**INFILL DEVELOPMENT
CONCEPT PLAN**

RESPONSE TO COMMENTS

CAMBRIDGE, MASSACHUSETTS
ISSUED NOVEMBER, 2016

FIGURE R1.3.1

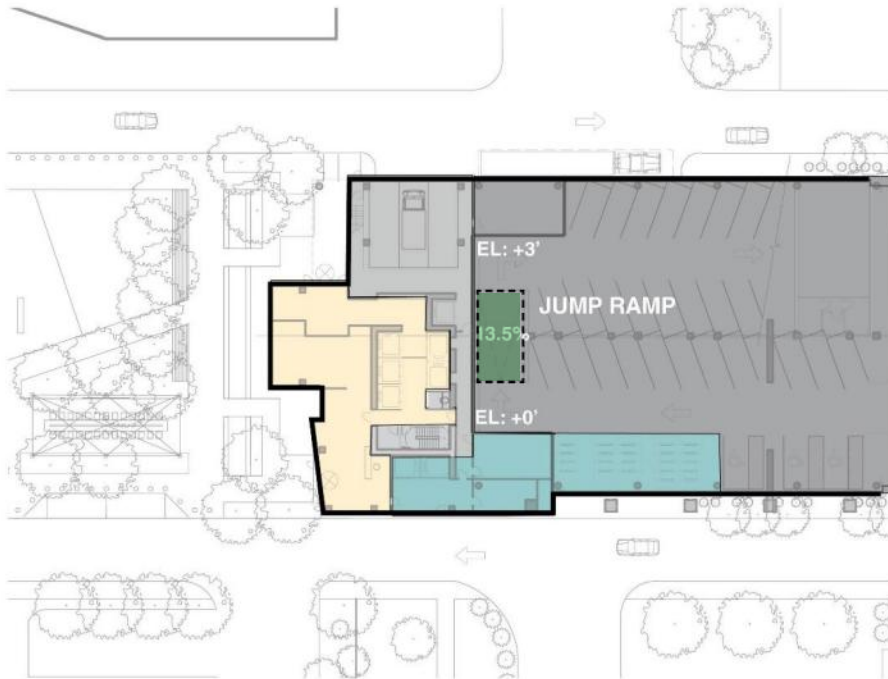
R1.3.1 BALCONIES: Applicant received three suggestions that the residential buildings include balconies. As indicated in the Residential Facades and Fenestration Guidelines, the residential buildings will provide balconies. The exact size and location will be included with the Design Review submission for the residential buildings. **FIG. R1.3.1** represents a conceptual study of the North Residential building with such proposed balconies in the slots per the design guidelines.

R1.3.4 CHARACTER OF BINNEY STREET FRONTAGE: The CRA staff has inquired about the relationship of parking within the Blue Garage to the Binney Street façade. **FIG. R1.3.1** represents a conceptual study of the proposed North Residential building with the parking masked in the same building fenestration. Screening elements will be consistent with the design guidelines for parking structure screening.

FIGURE R1.4.1

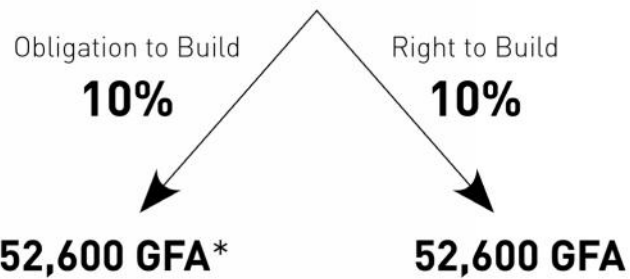
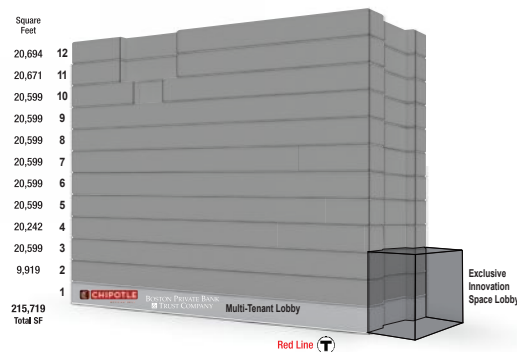
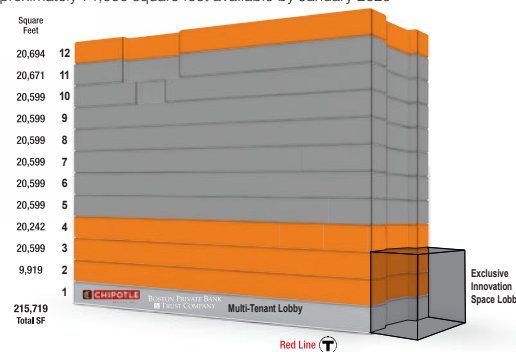
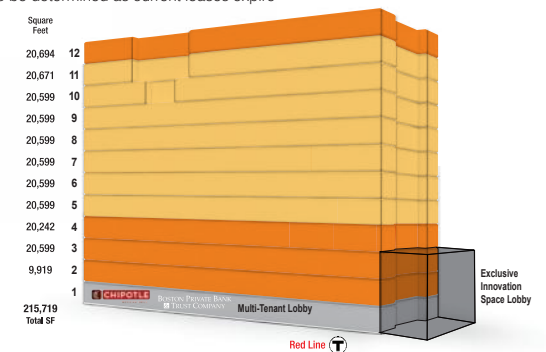
R1.4.1 CONCEPTUAL DESIGN AND OPERATIONAL DETAILS: CRA and CDD staff memos requested additional detail about the character and operation of the innovation space at 255 Main Street. Conceptual details on the character and phasing of the innovation space can be found in **FIG. R1.4.1- FIG. R1.4.4** Additional details about the entry design and interior character will be included as part of a separate Design Review Packages prepared specifically for the Innovation Space at 255 Main Street. Identity and entry opportunities are represented in **FIG. R1.4.4**

FIGURE R1.5.1

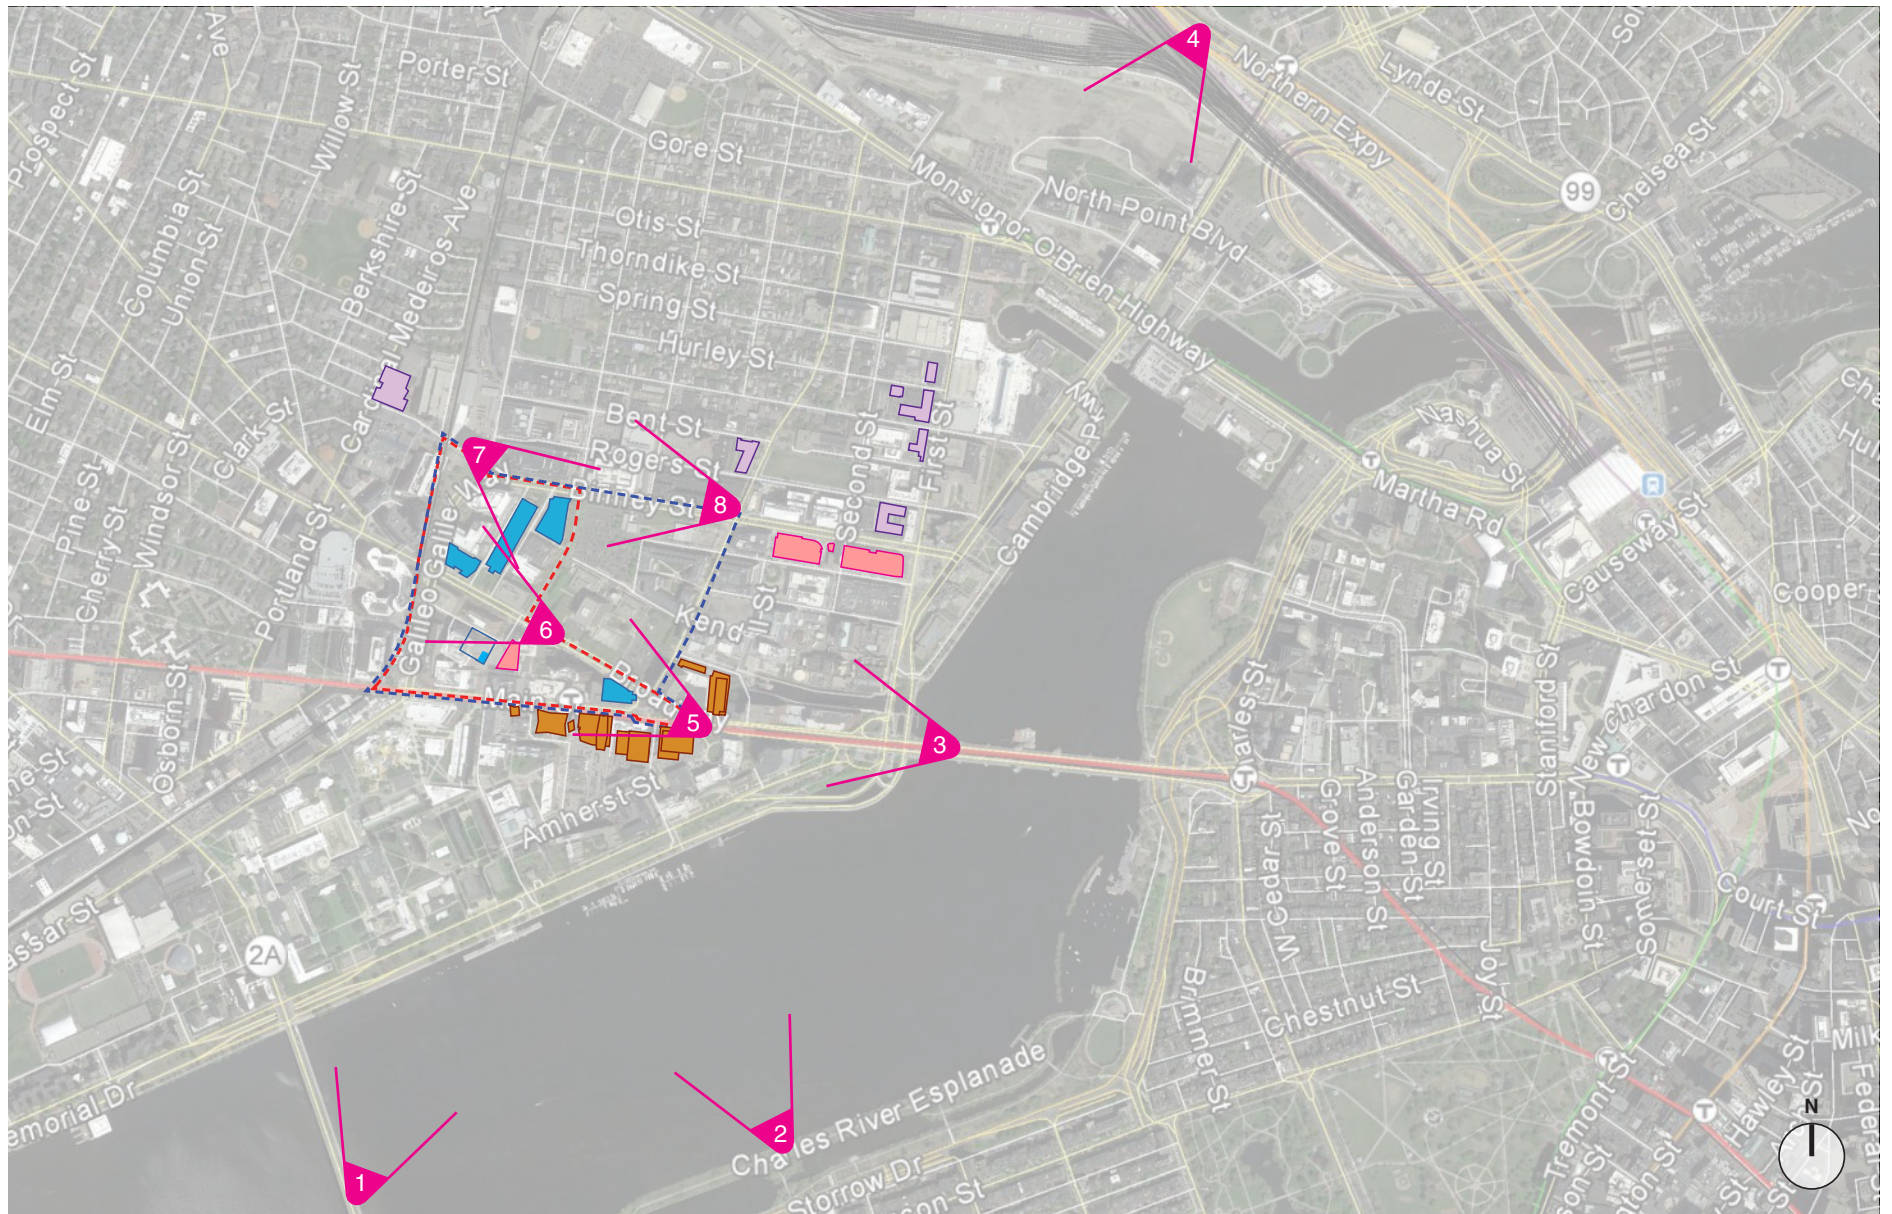
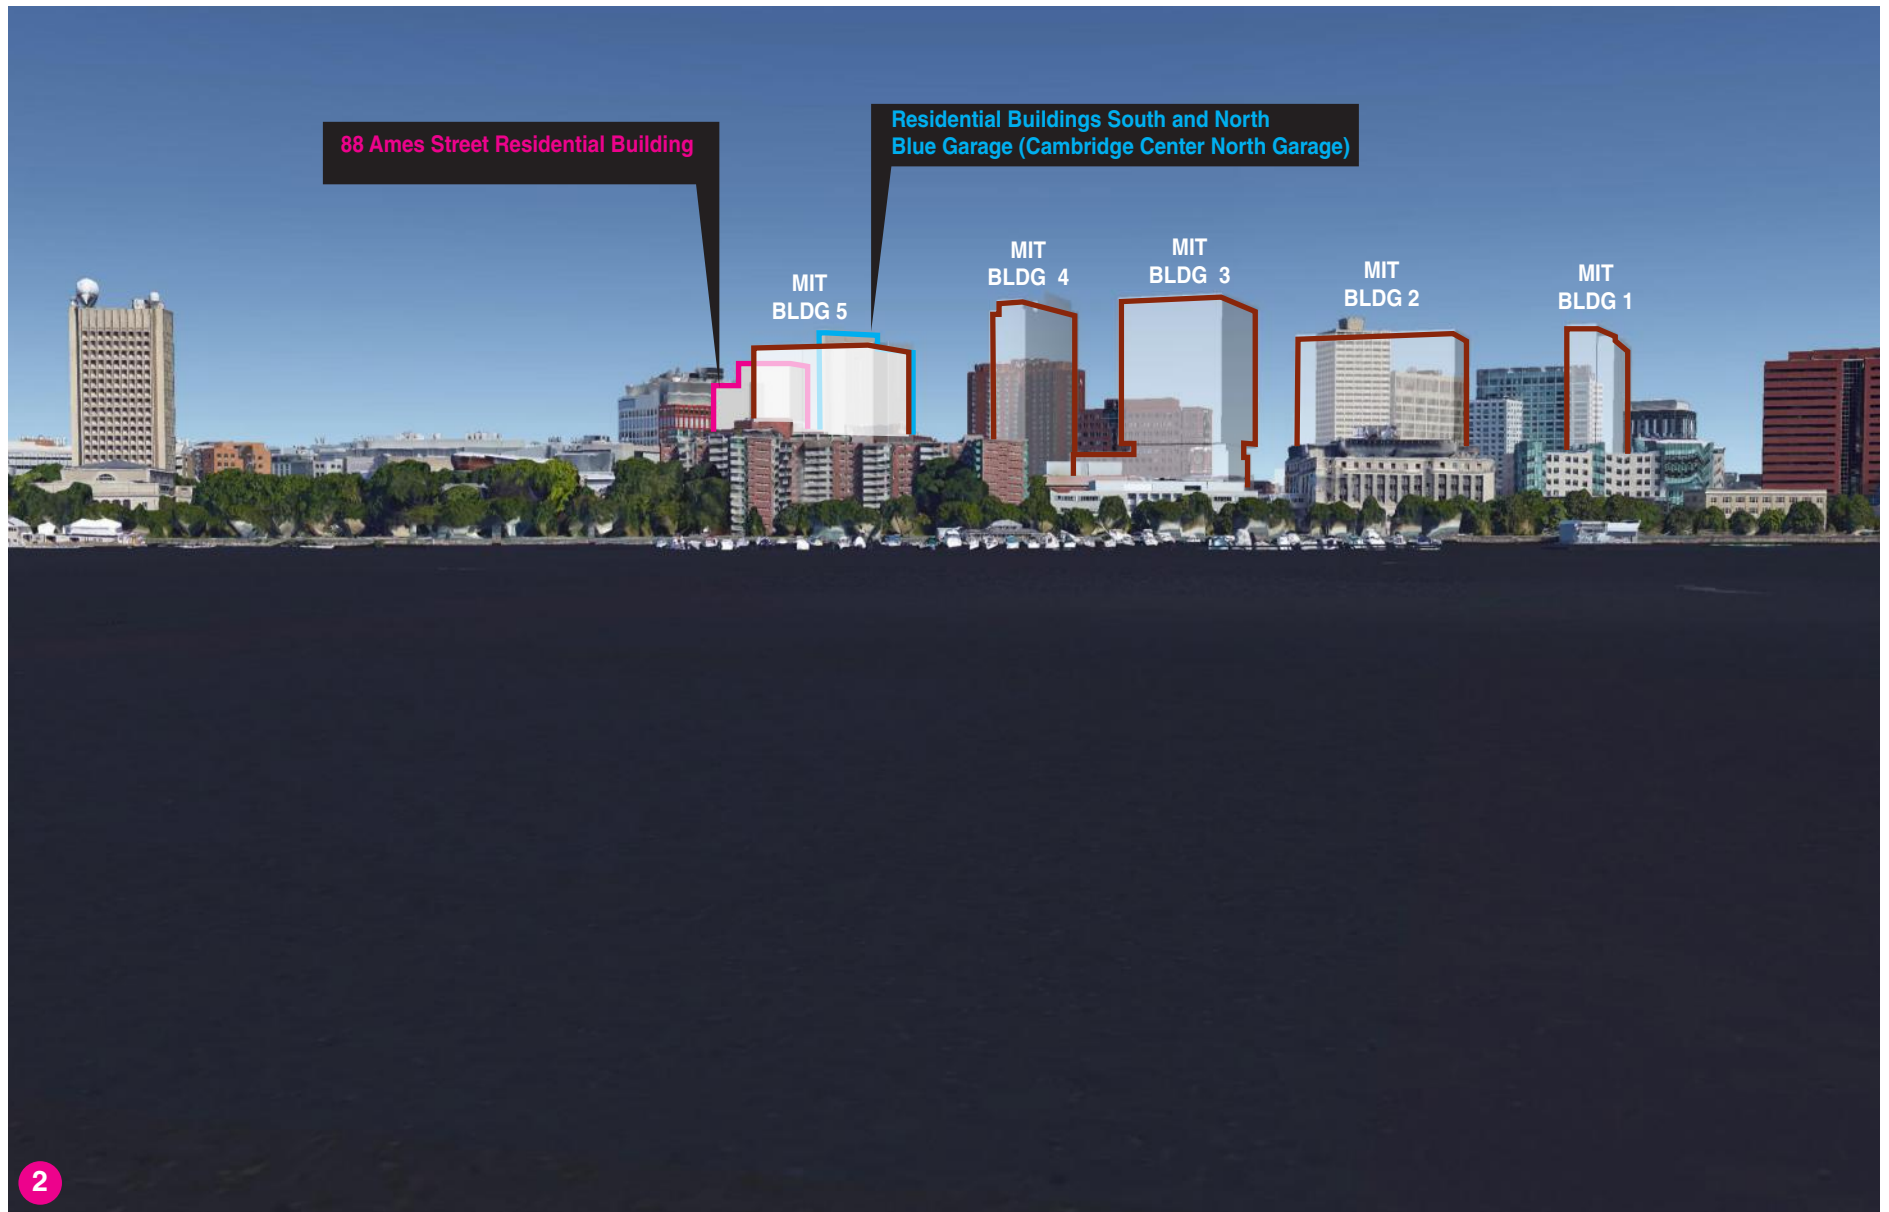
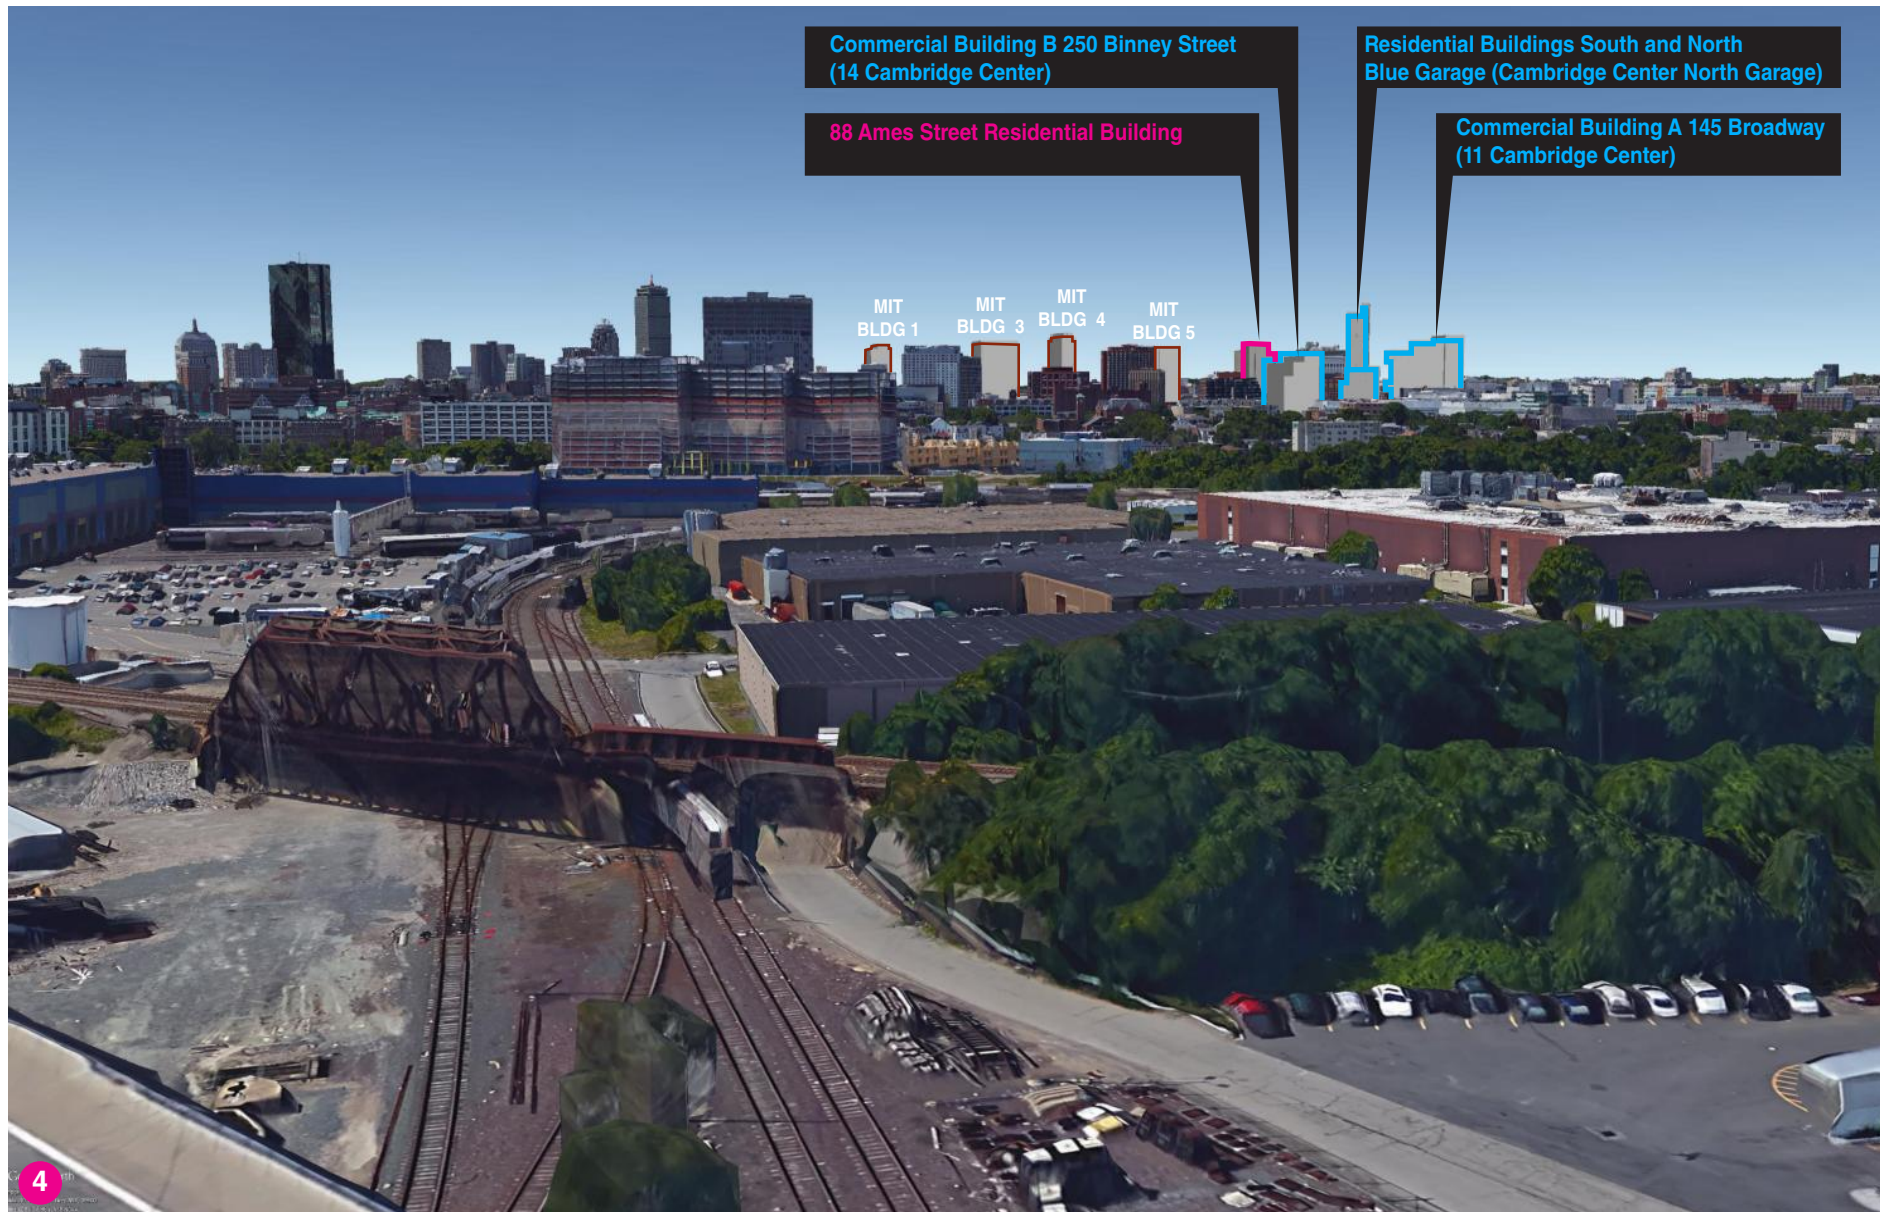
R1.5.1 DISTANCE VIEWS OF THE PROJECT: The CRA Board has requested additional massing views of the project from various distances, especially the South Residential tower. **FIG. R1.5.1A-F** represents views from similar locations to the requested views from 88 Ames Street Residences Project. Massing views include the proposed MIT PUD Projects to represent the future context of the MXD proposed buildings.
